ATTENDED PLAN SHOWING ADDITION OF EXTRA BAY TO NORTH WING.

WELLINGTON CENTRAL LIBRARY.

DRAWING NO. O.

NOTE: AN ADDITIONAL BAY IS TO BE INTRODUCED IN THE LENGTH OF THIS NORTH WING AS INDICATED ON THE AMENDED PLAN DRAWING NO. O.
THIS WILL BE A COMPLETE MODIFICATION OF THE BAY INCLUDED WITHIN THE RECTANGLE A B C D.

ROOF PLAN.

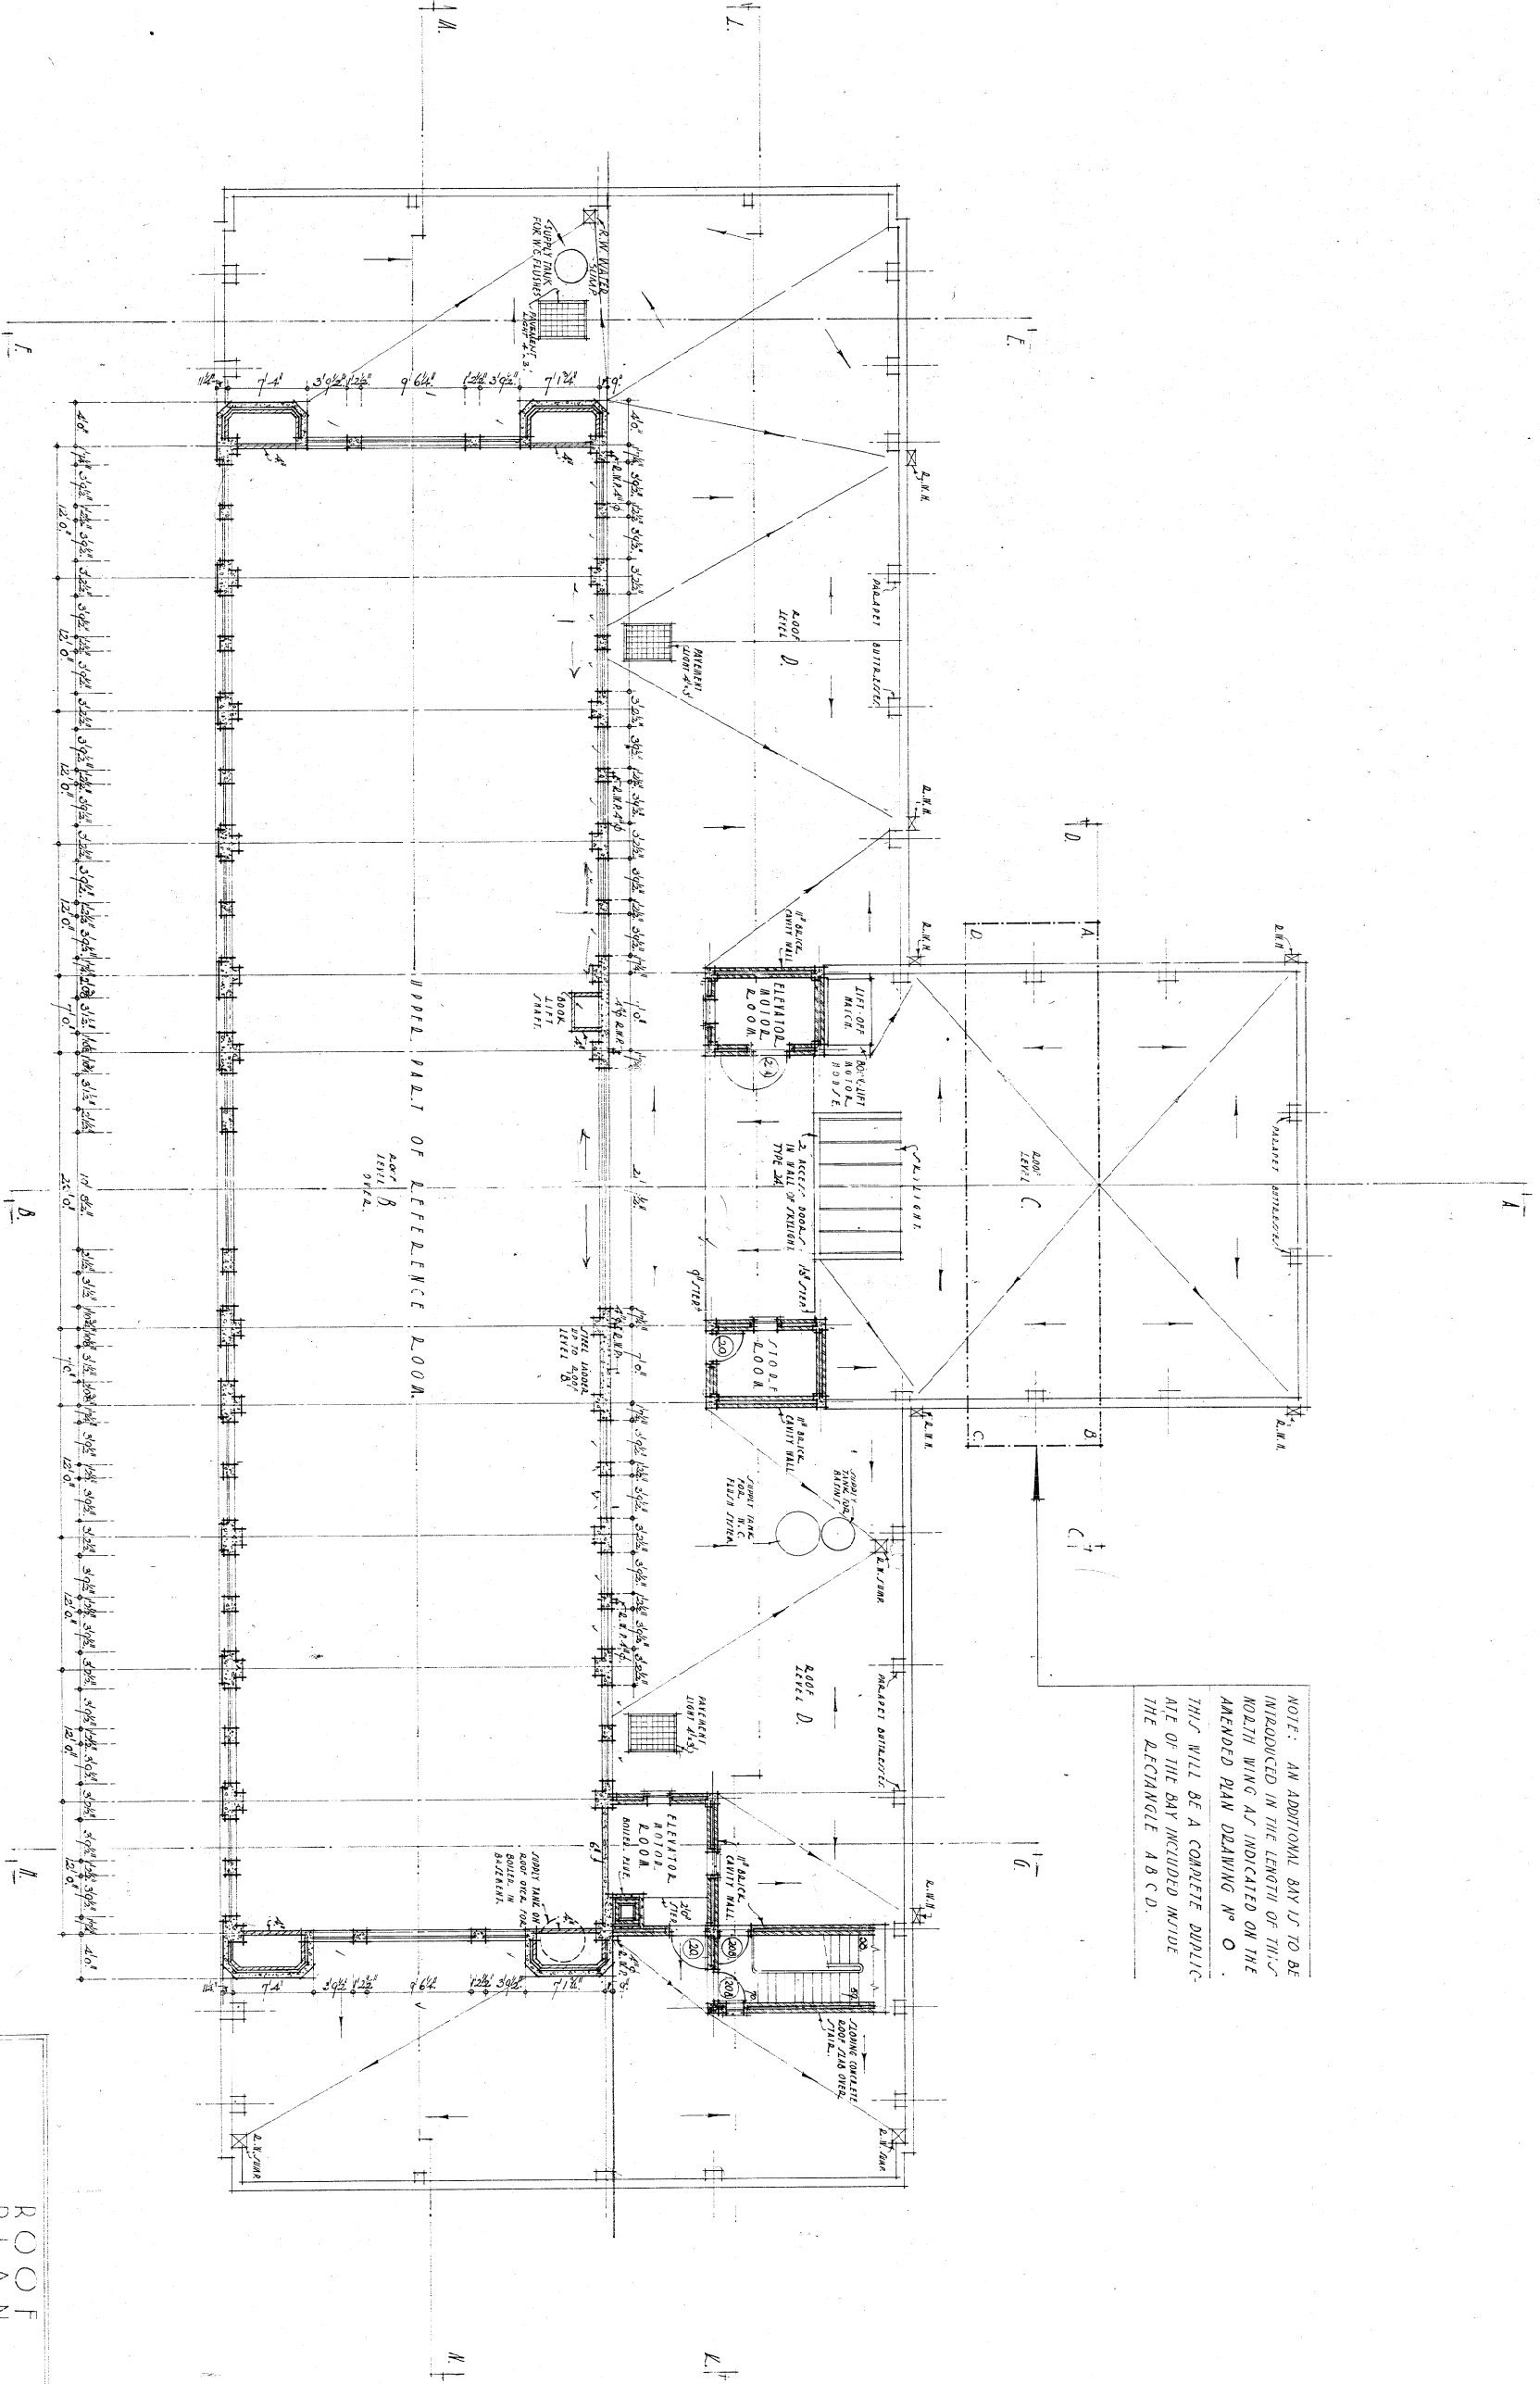
NOTE: AN ADDITIONAL BAY IS TO BE INTRODUCED IN THE LENGTH OF THIS NORTH WING AS INDICATED ON THE AMENDED PLAN DRAWING NO. O. THIS WILL BE A COMPLETE DUPLICATE OF THE BAY INCLUDED INSIDE THE DECIANGLE A B C D.

SECTIONS
A.B., C.D., E.F., G.H.

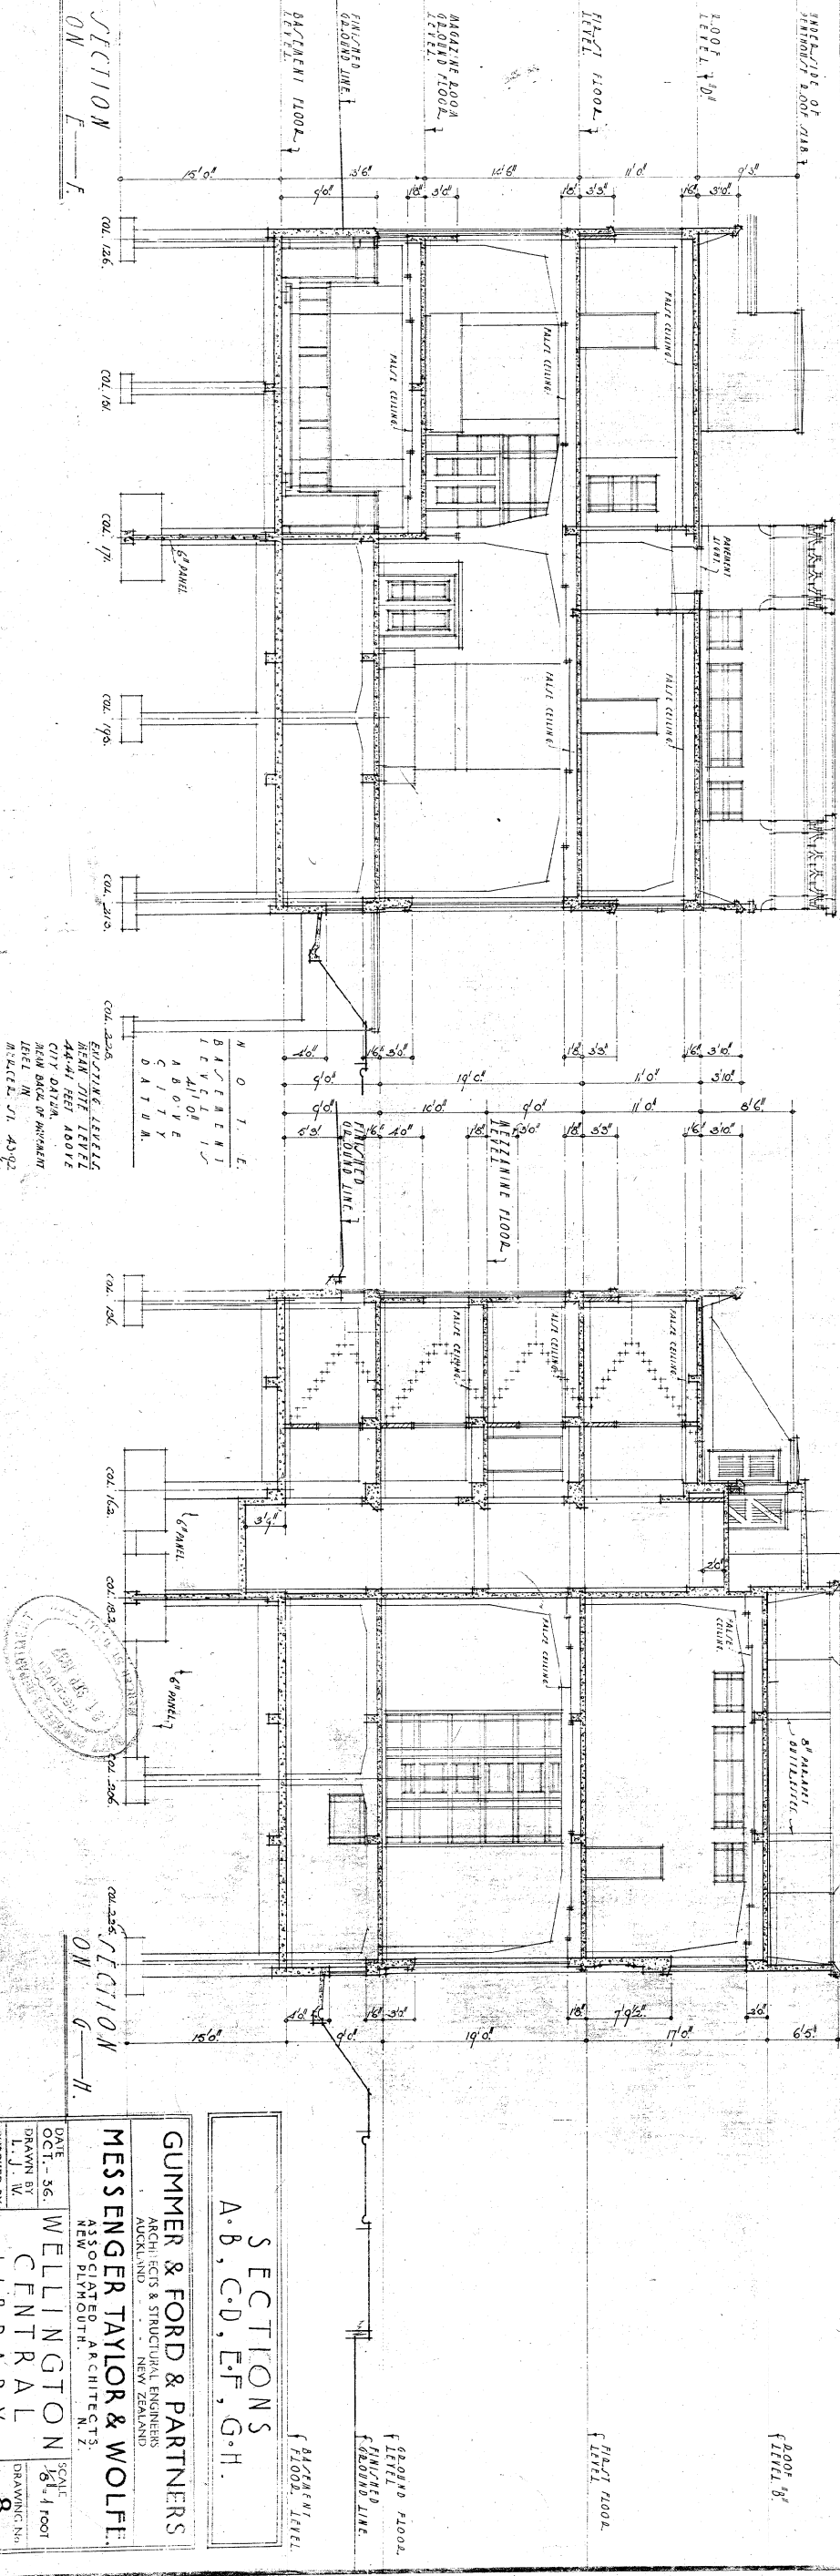
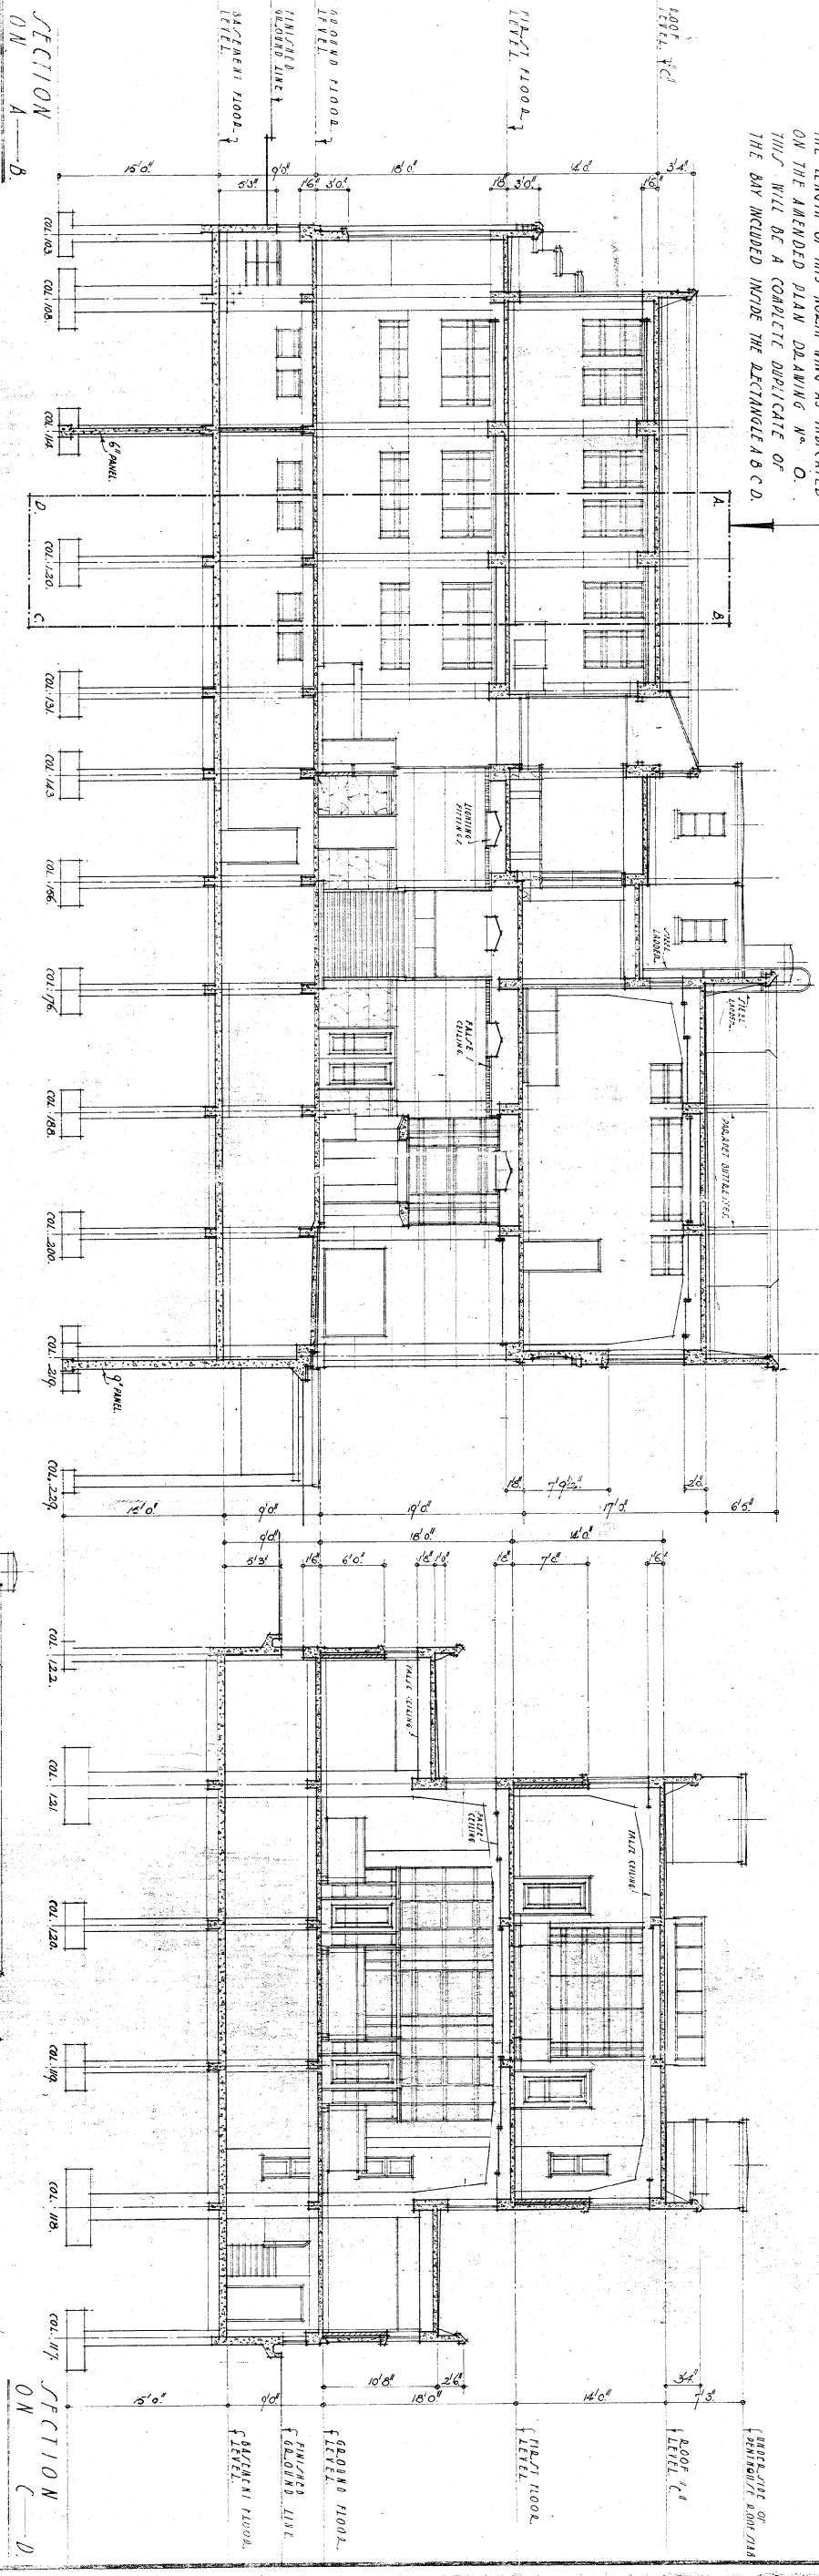
NOTE: AN ADDITIONAL COPY IS TO BE INTRODUCED IN THE LENGTH OF THIS NORTH WING AS INDICATED ON THE AMENDED PLAN DRAWING N^o. O. THIS WILL BE A COMPLETE DUPLICATE OF THE ONE INCLUDED INSIDE THE DECKING A B C D.
